Eastern Regional Power Committee

Sub: Minutes of the 158th PCC meeting held on 12.05.2026

MINUTES
OF
158th PCC MEETING

Figure 1: Network across the affected area

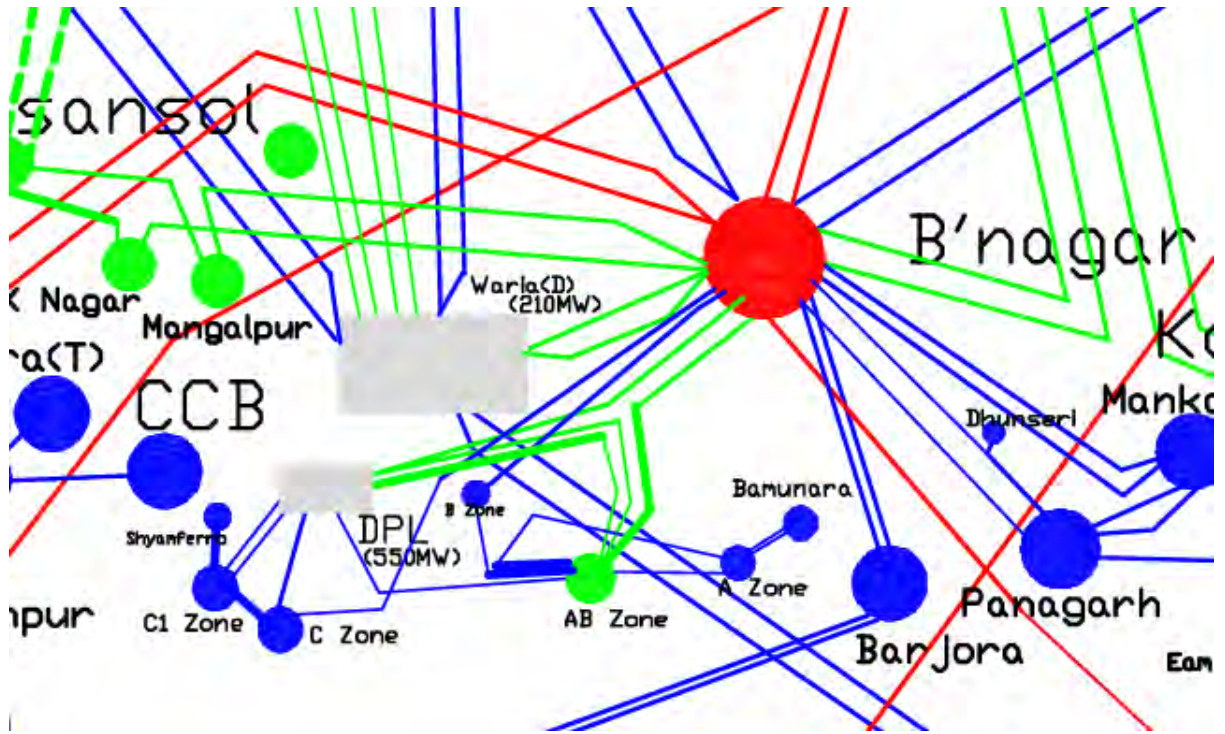
- Switching operation of ICT-2 at Bidhanagar S/s may be explain as initiating factor for system collapse.
- During planned S/D of ICT-3, remaining ICT loading was not N-1 compliance. Real time monitoring and restriction of remaining ICTs loading in safe side were not adequately ensured.

Reason for Busbar tripping

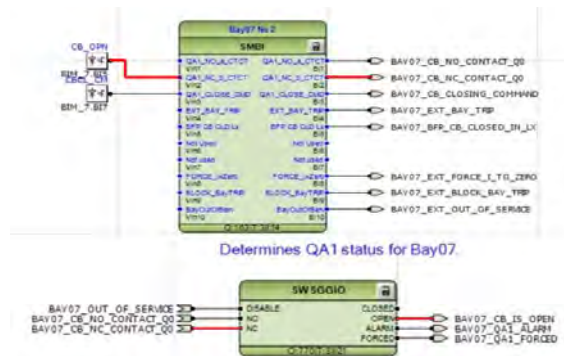
- CB open status stays during charging of 315 MVA 400/220/33 KV ICT 2 LV bay.
- CB close command did not come.
- As per relay(ABB REB670) configuration , current fed by 315 MVA 400/220/33 KV ICT 2 bay during charging (1.5 KA) could not be counted to BUS B. This causes to produce differential current and operation of BB relay.

They submitted that they would check the CB close command issue by availing ICT shutdown.

Figure 1: Network across the affected area

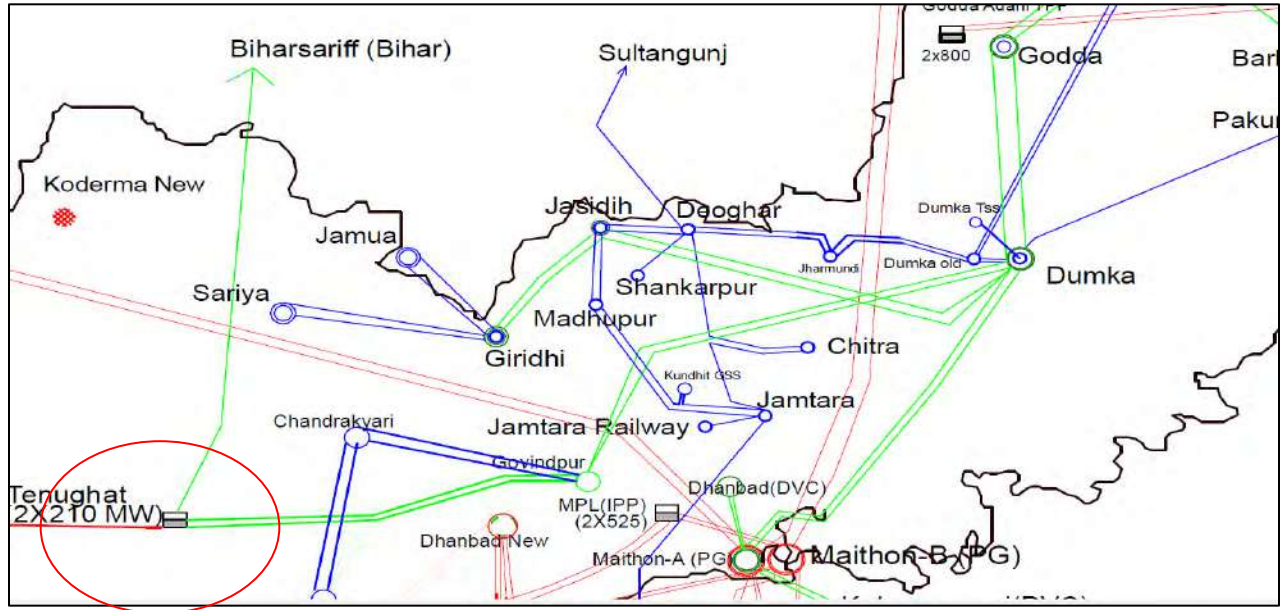
- Submit an action plan for revival of Bus coupler bay so that both bus can be charged with uniform feeder segregation to enhance system reliability
- Provide an update on replacement of E/M BB relay with Numerical Relays in compliance with CEA regulation and expedite the process.

- Ensure preventive maintenance of S/s equipment's is done in accordance with CEA Grid standard Regulation 2010.
- Clarify the reason for non-uniform distribution of feeders between both buses (All line feeders and GTs in 220 kV Bus-II).

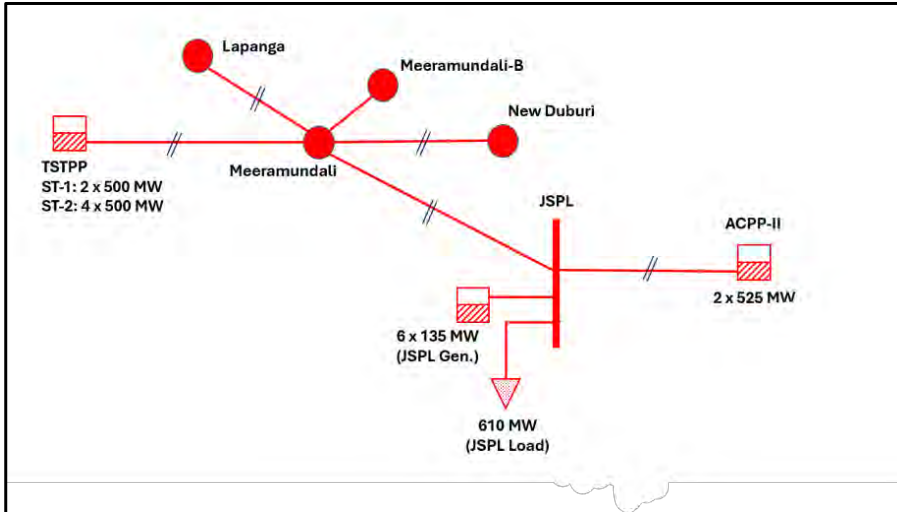
Commented [BN1]: Restoration time may be mentioned for both lines
